Technical Service Information

FORD AX4N SOFT 1-2 UPSHIFT

Figure 1

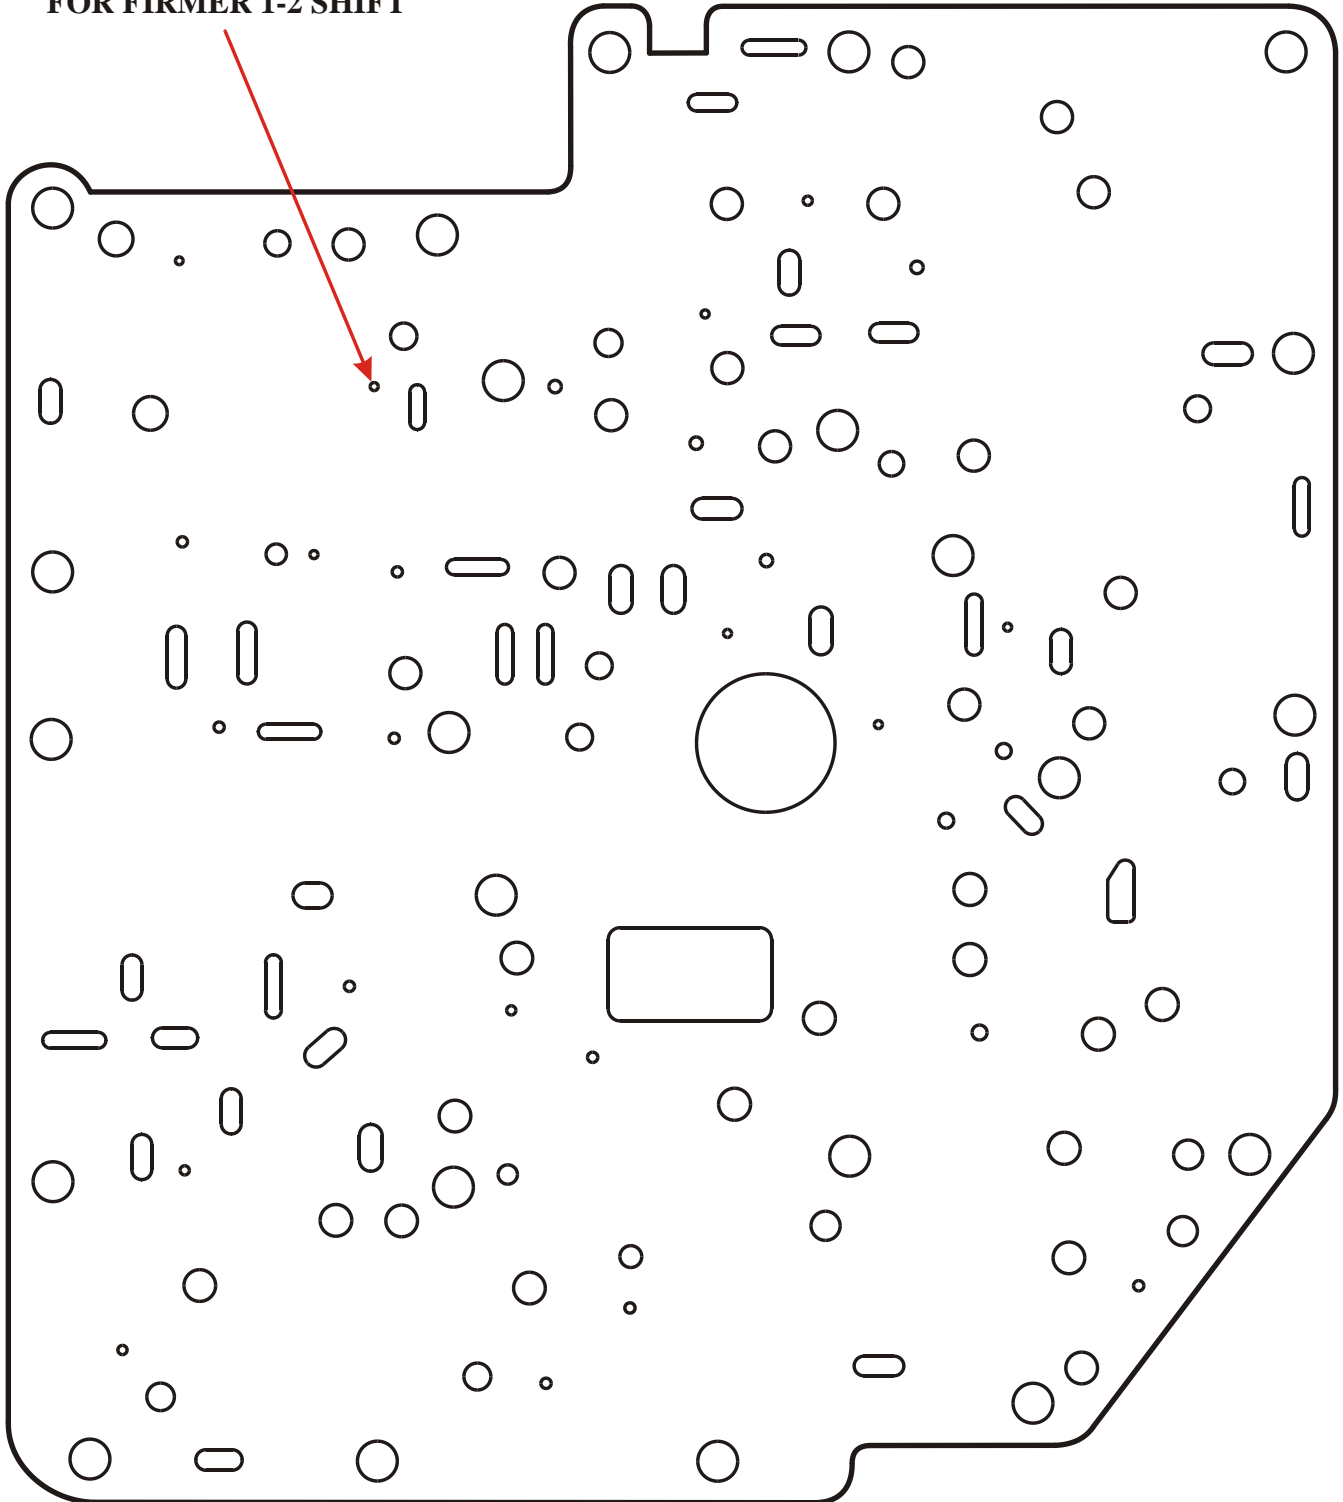
- COMPLAINT:** Before and/or after rebuild, the vehicle exhibits a soft 1-2 upshift, on Ford vehicles equipped with the AX4N transaxle.
- CAUSE:** The cause may be, not enough volume of oil being fed to the intermediate clutch pack.
- CORRECTION:** Drill the intermediate clutch feed hole in the valve body spacer plate out to .075"-.093" as shown in Figure 1. The size of the hole determines the quality of the shift, the larger the hole, the firmer the shift will be.

**DRILL THIS HOLE
OUT TO .075"-.093"
FOR FIRMER 1-2 SHIFT**
